**READING OPERATIONS CENTER DRIVER BREAKROOM & SHOP BAY
RENOVATION PROJECT
PROJECT # 10-2026
For the
SOUTH CENTRAL TRANSIT AUTHORITY**

ADDENDUM NO. 2

Addendum #2

Questions and Answers

SHEET NUMBER:
A-102

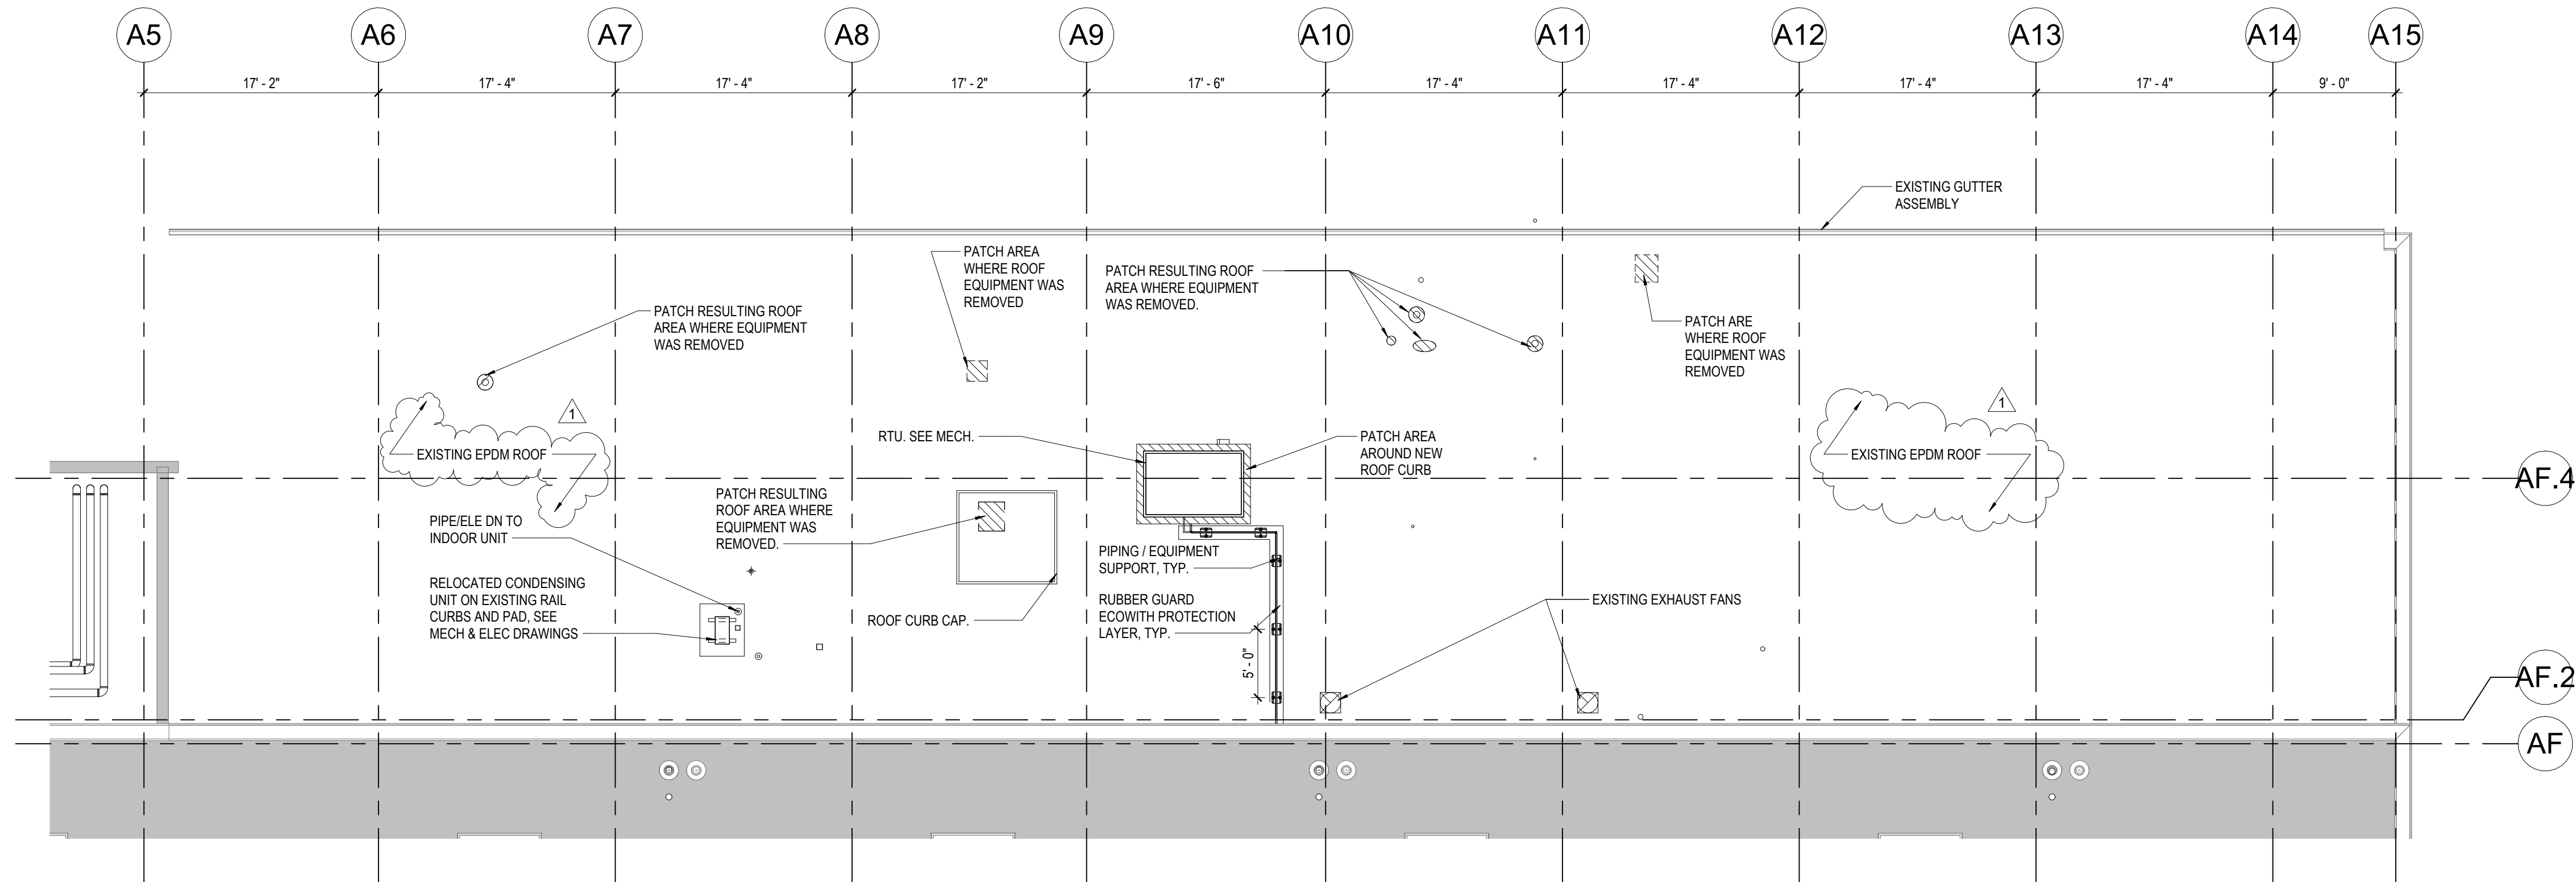
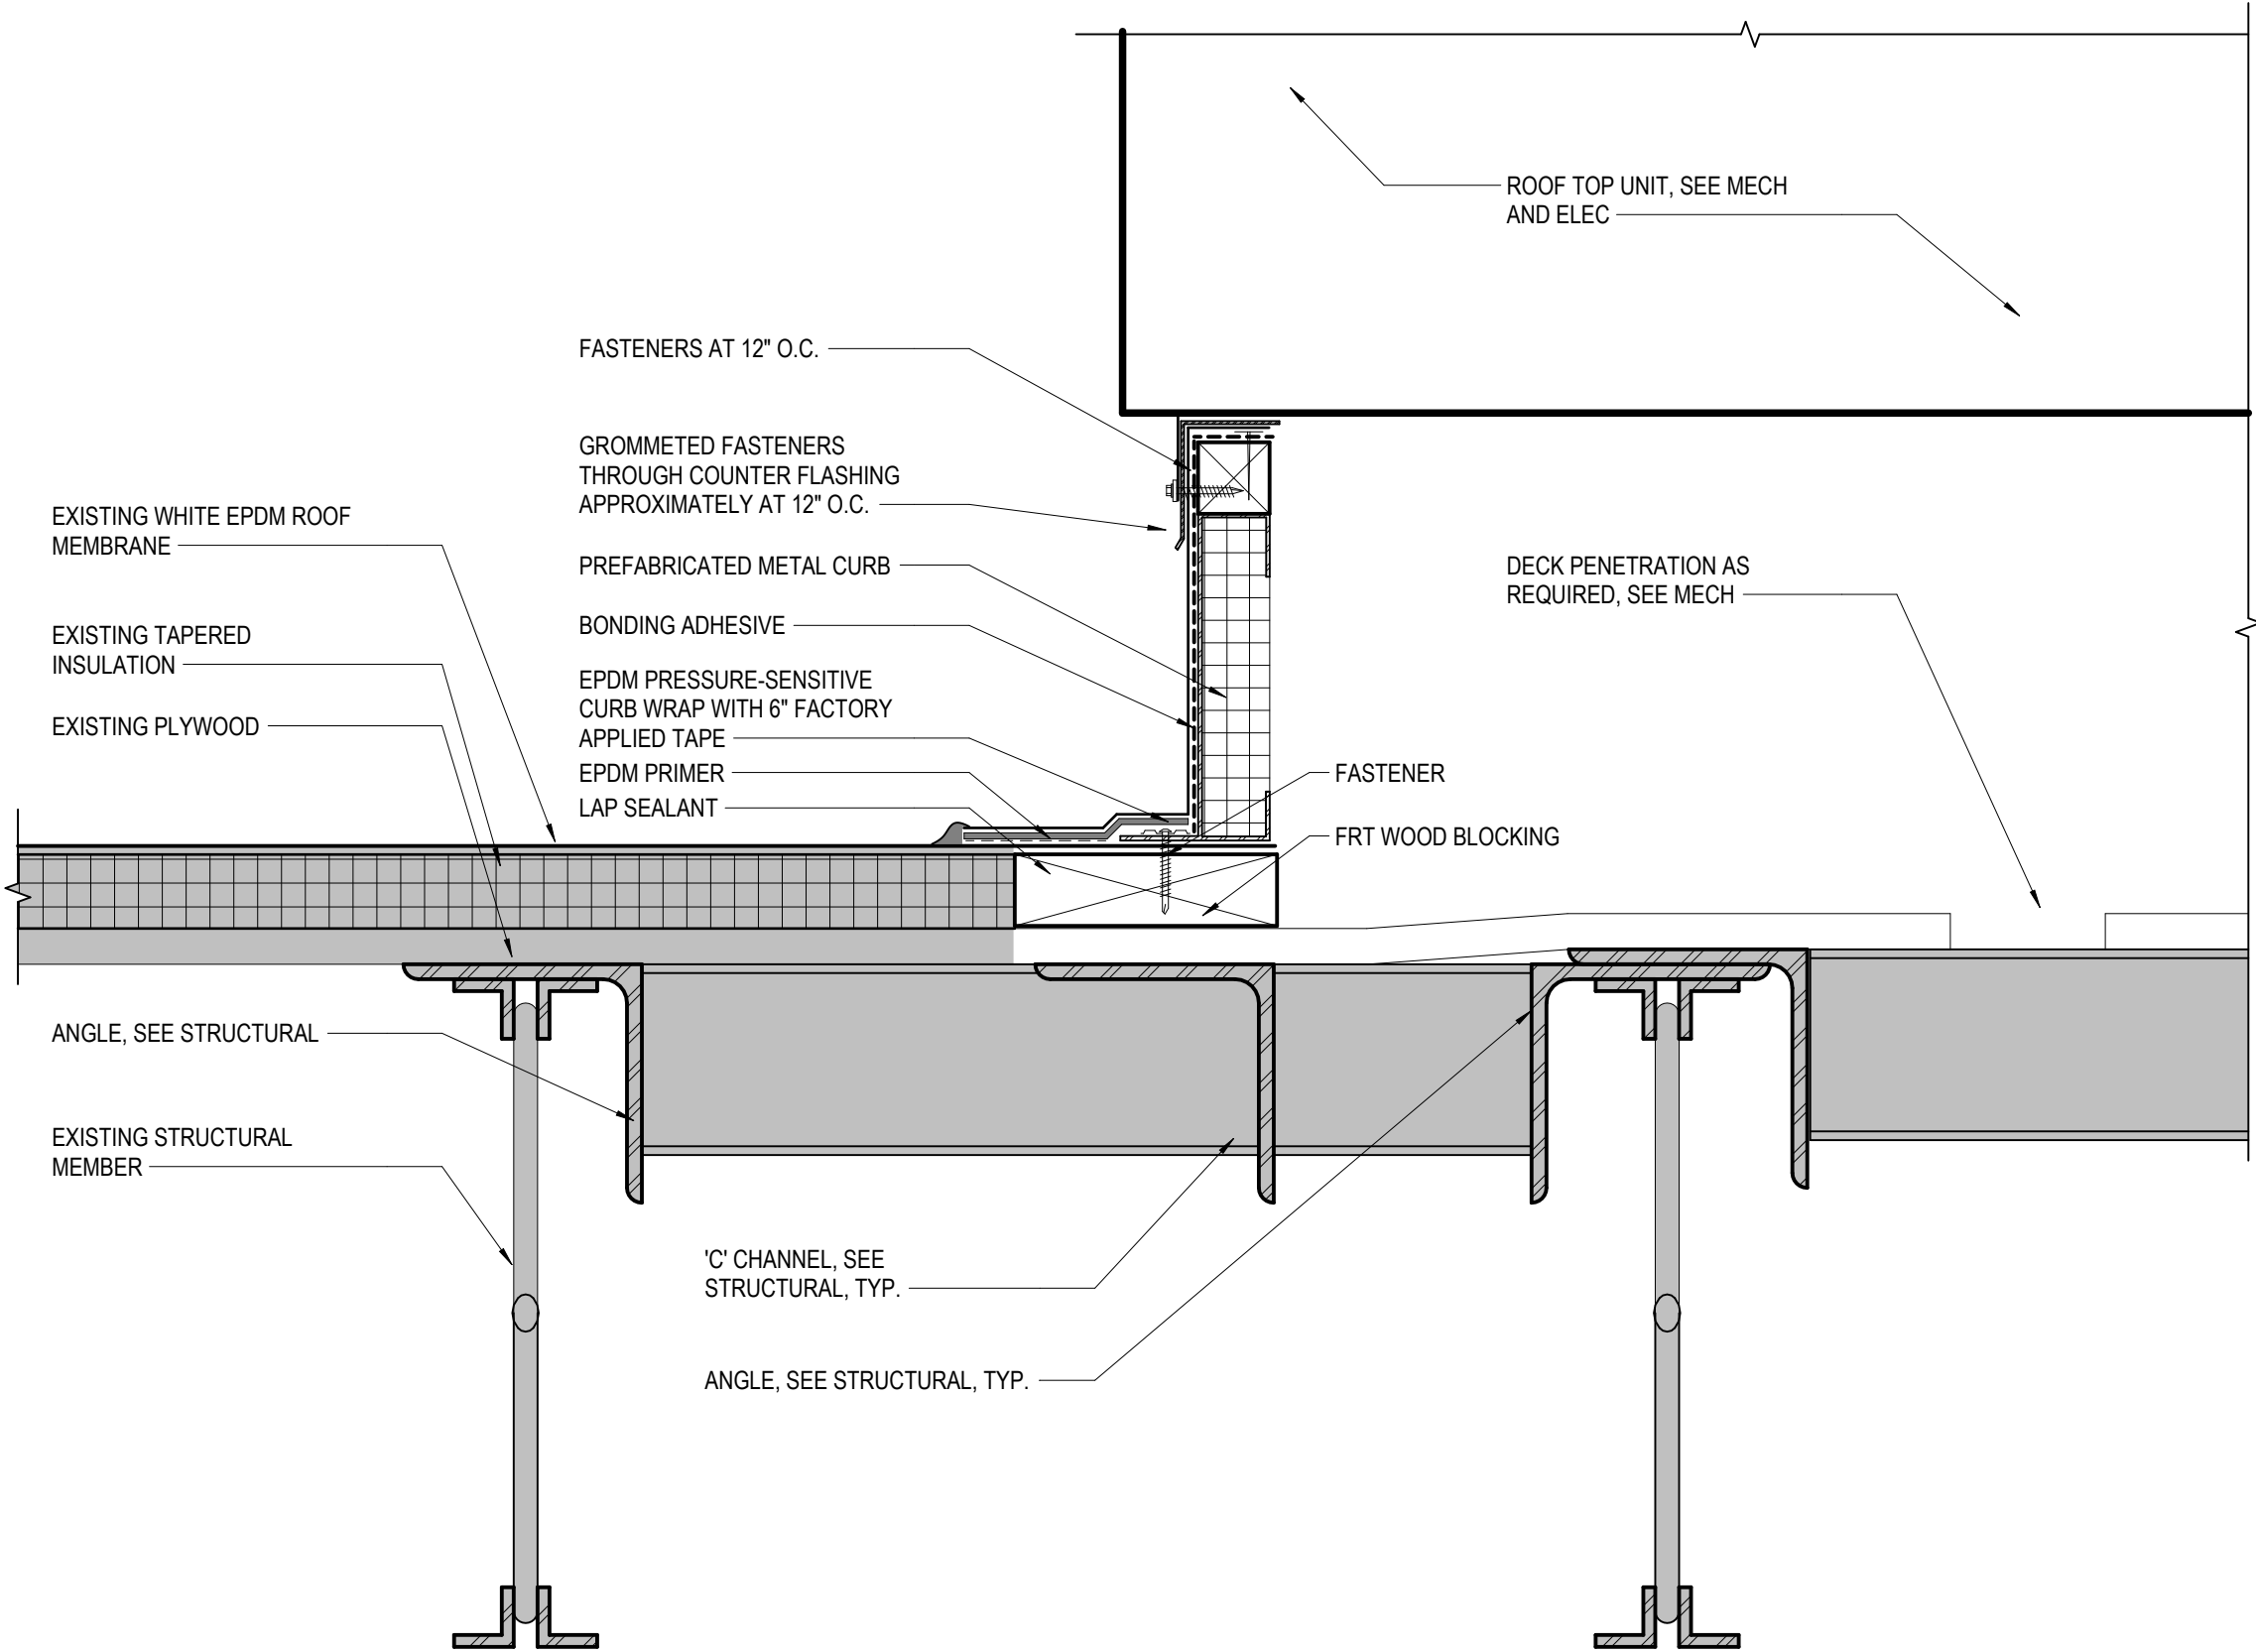
16. Please provide specification and panel manufacturer for new wash bay wall shown on A-102, 3-4-5 on A-301.

17. Please provide specification for the safety net and track cable system noted on A102.

SCTA RESPONSE: Specification 102200 - Modular Partitions is included with Addendum #2.

SCTA RESPONSE: Refer to specification 118129 - Horizontal Fall Protection.
